SUBDIVISION REVIEW SHEET

CASE NO.: C8-2022-0112

SUBDIVISION NAME: Velocity Preliminary Plan

CITY OF AUSTIN –DEVELOPMENT SERVICES DEPARTMENT SUBDIVISION APPLICATION – MASTER COMMENT REPORT

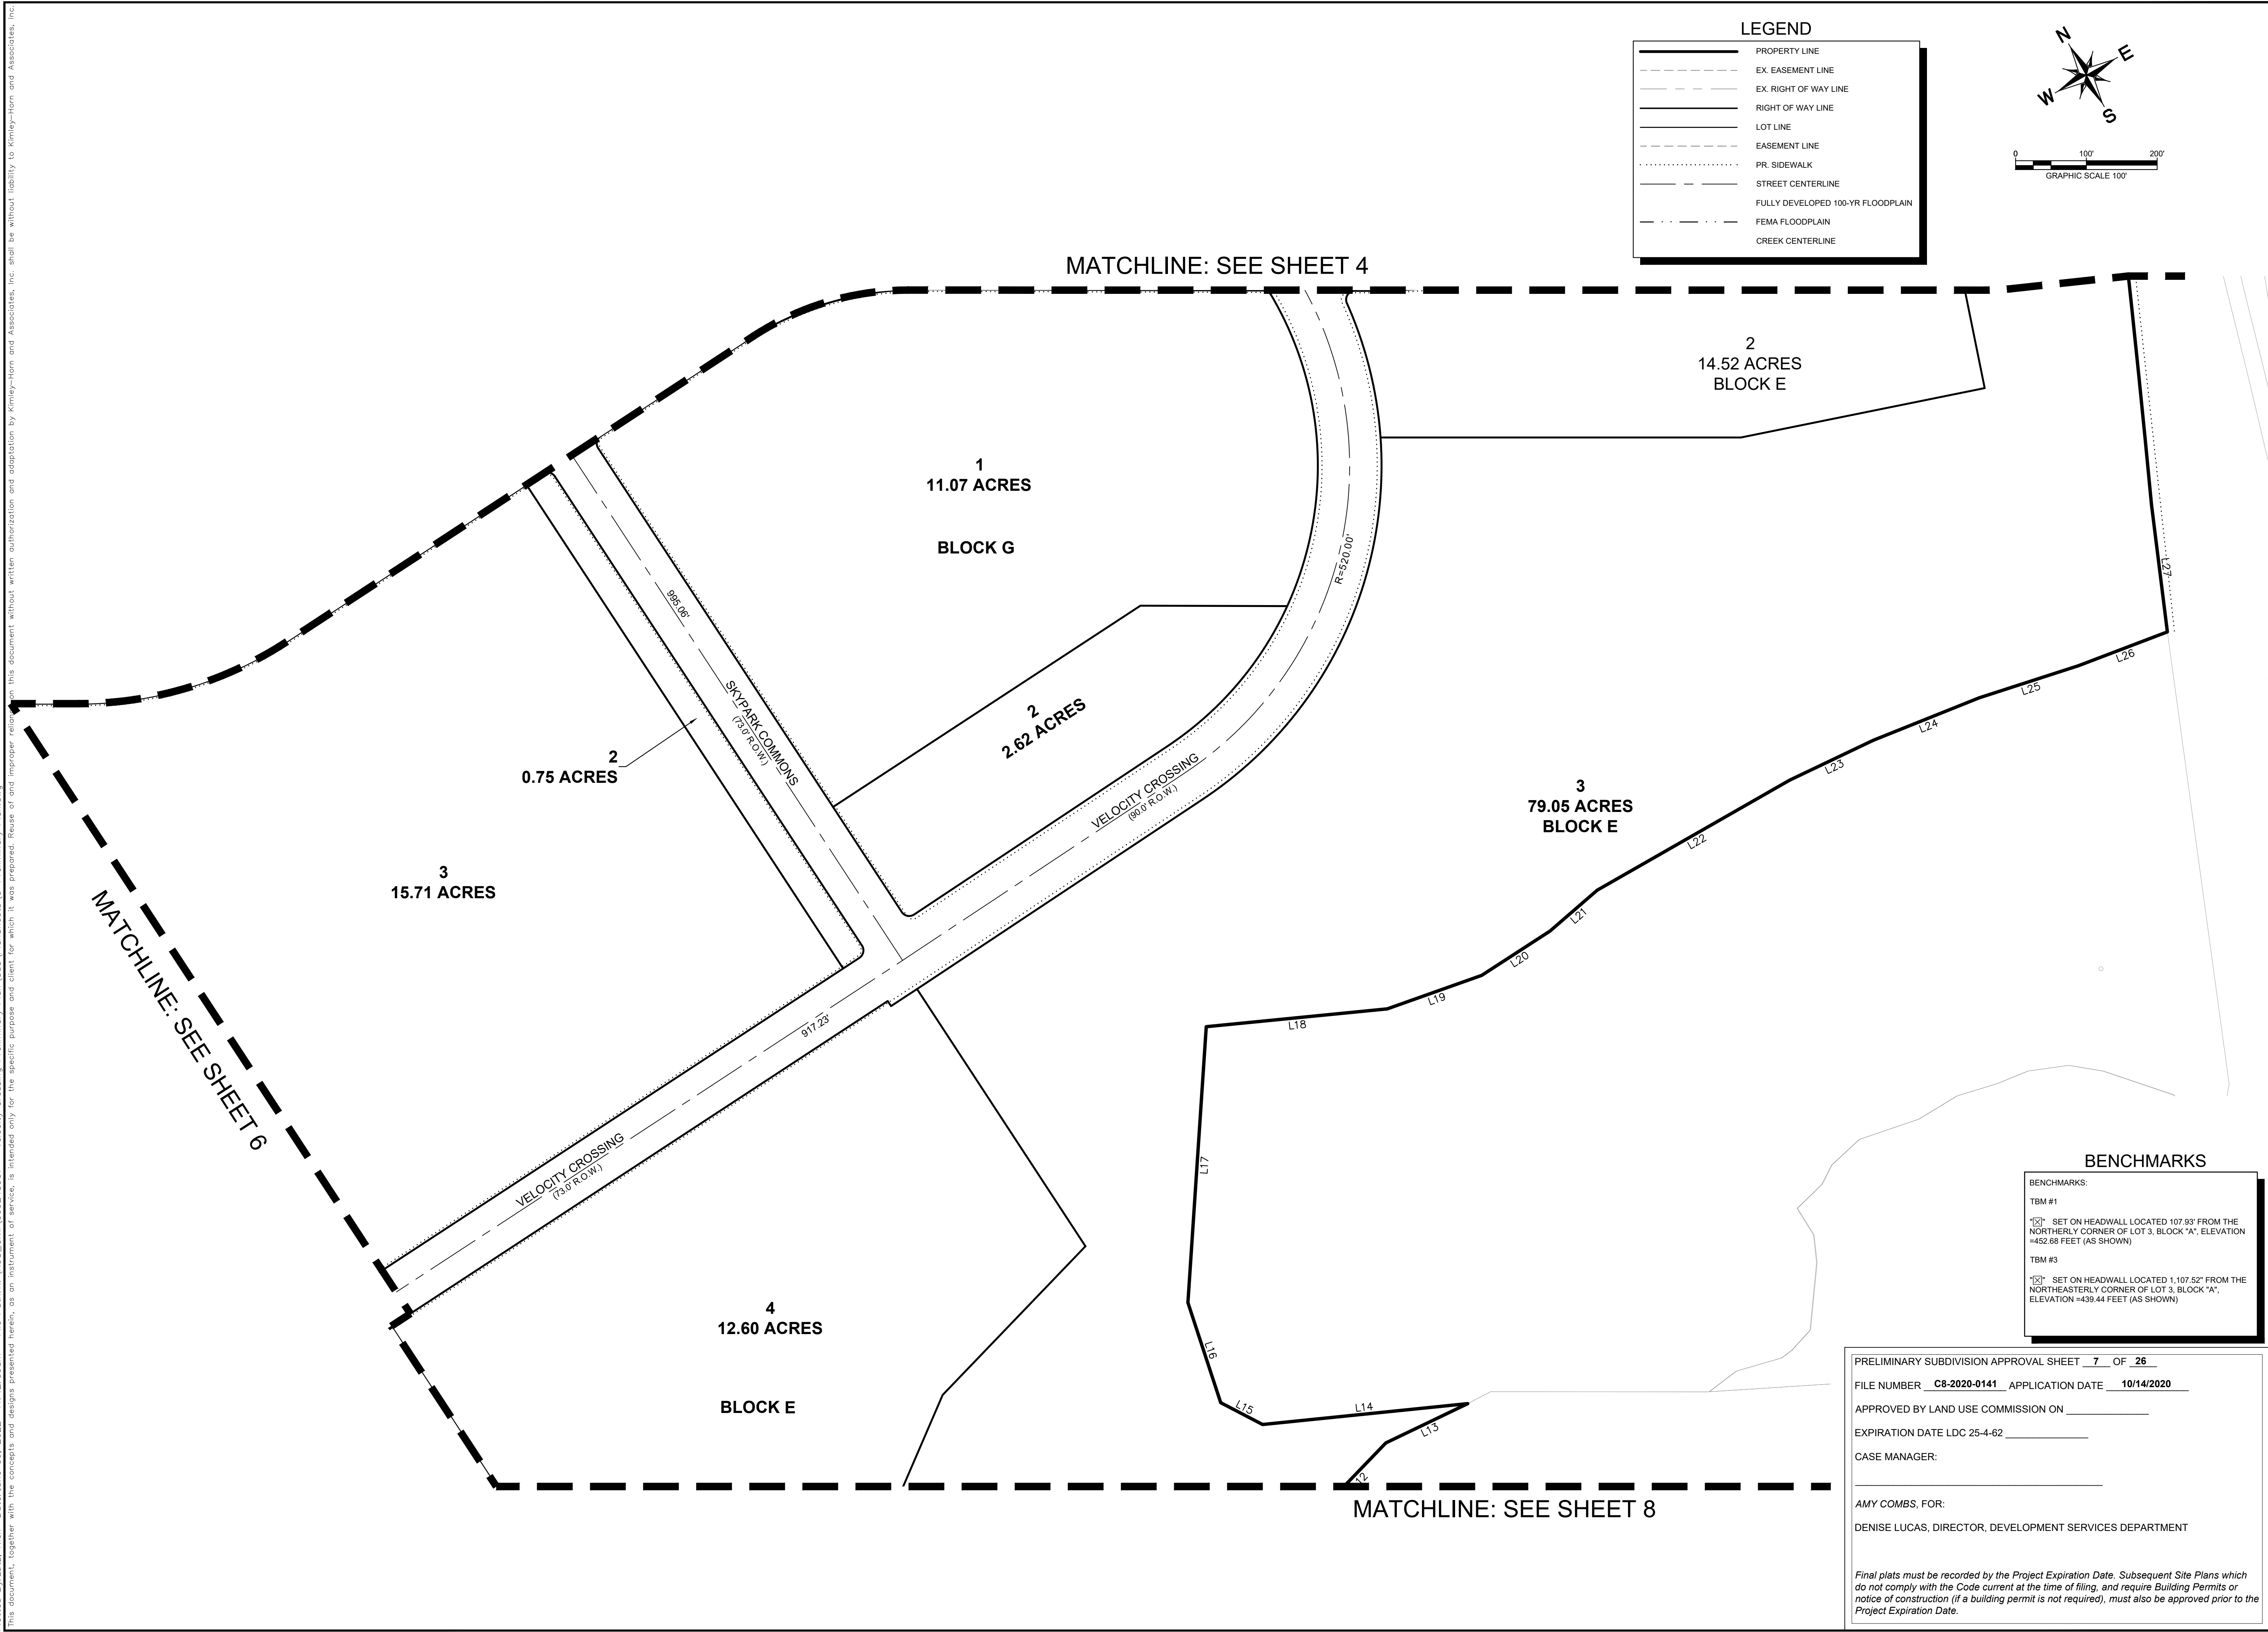
- SR9.** Please remove all of the building footprints from the surrounding property- for instance on sheet 3 and sheet 5 there appears to be contours or building footprints for the surrounding property (25-1-83)
